City of Coconut Creek

InterOffice Memorandum

Subject: The Promenade - Silverspot
Theater

Requested Change: Modification to Elevations and Landscape Plans

1 OVERALL DEVELOPMENT PLAN
A100
1" = 50'

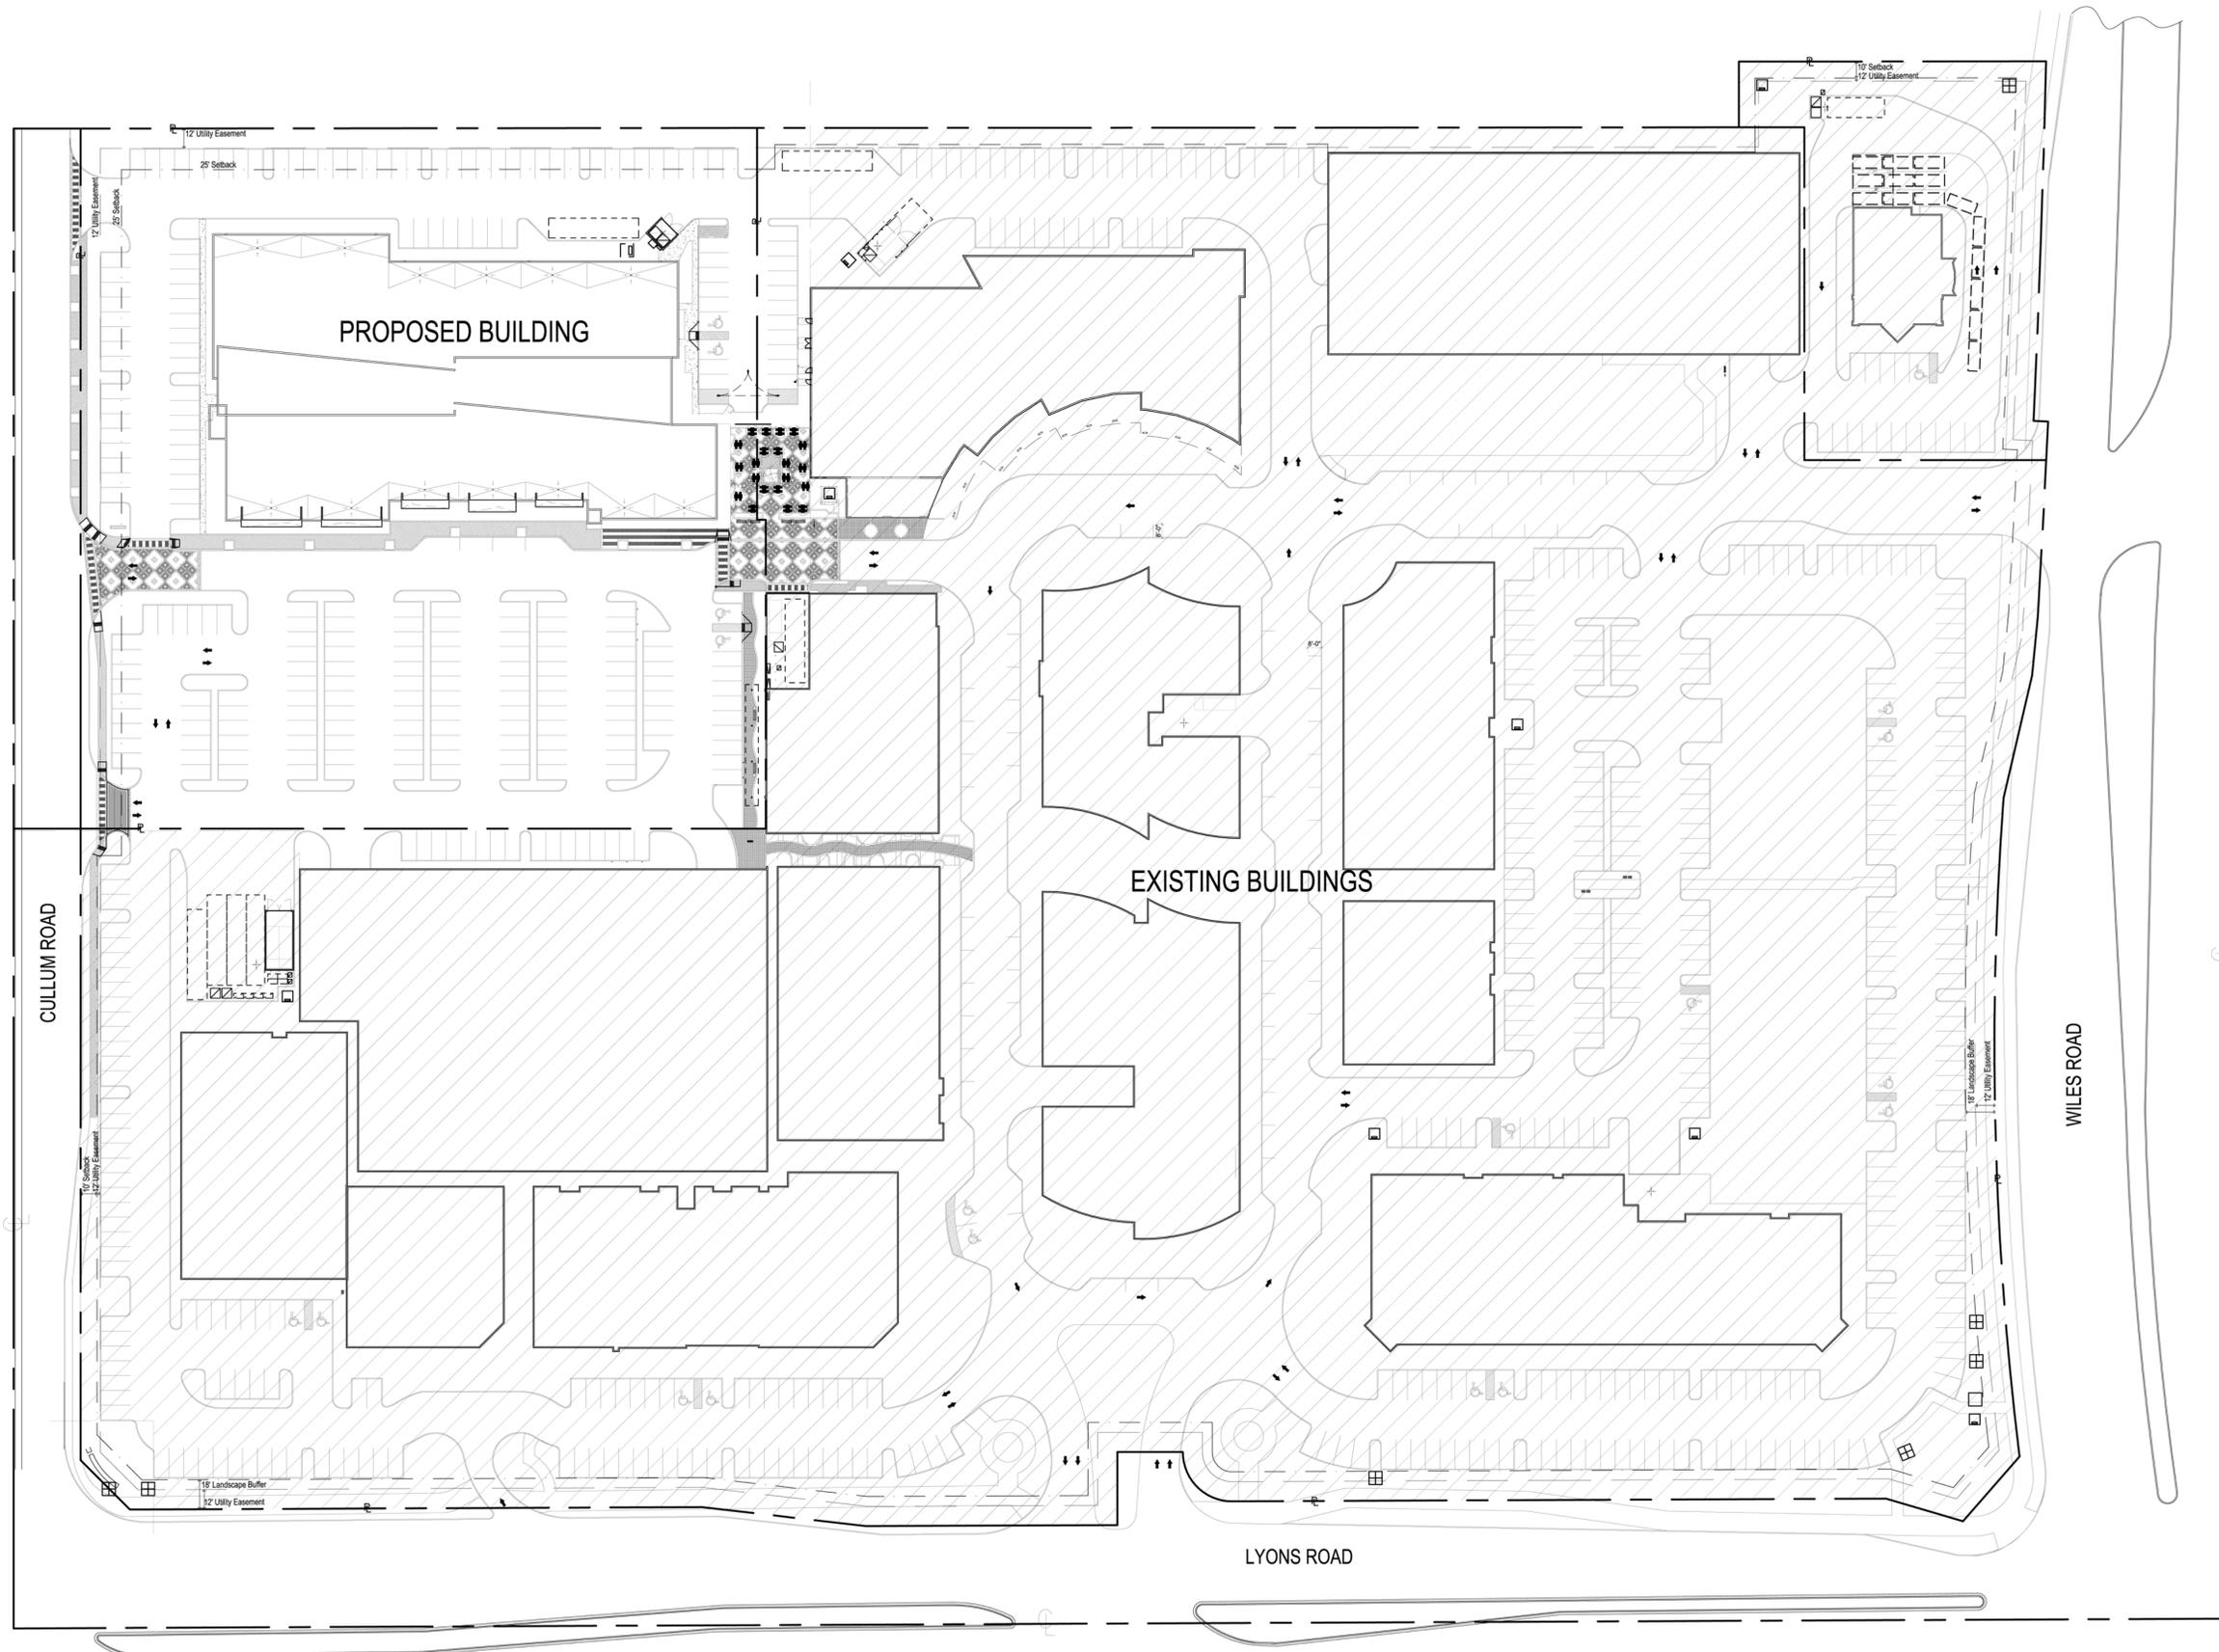
A100, A100T Site plans:

East side: exits from auditoriums deleted, hardscape/landscape revised

1 EAST ELEVATION
 A300 1/16"=1'-0"

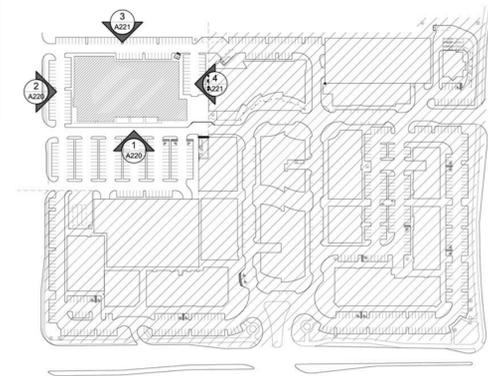
East elevation: -deleted exit doors from auditoriums

-added entrance doors/ revised storefront at Ground Level

-revised window sizes/ locations at Mezzanine Level

-deleted aluminum panels, added mosaic tiles

South elevation: -added 1 single exit door

-deleted aluminum panels, added mosaic tiles

3 WEST ELEVATION

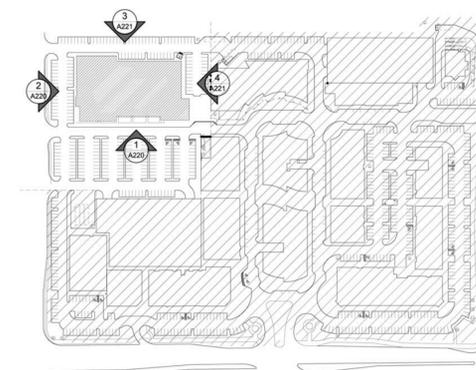
North elevation: -added doors/ revised storefront at Ground Level
-revised window sizes/ locations at Mezzanine Level
-deleted aluminum panels, added mosaic tiles
West elevation: -deleted exit doors from auditoriums
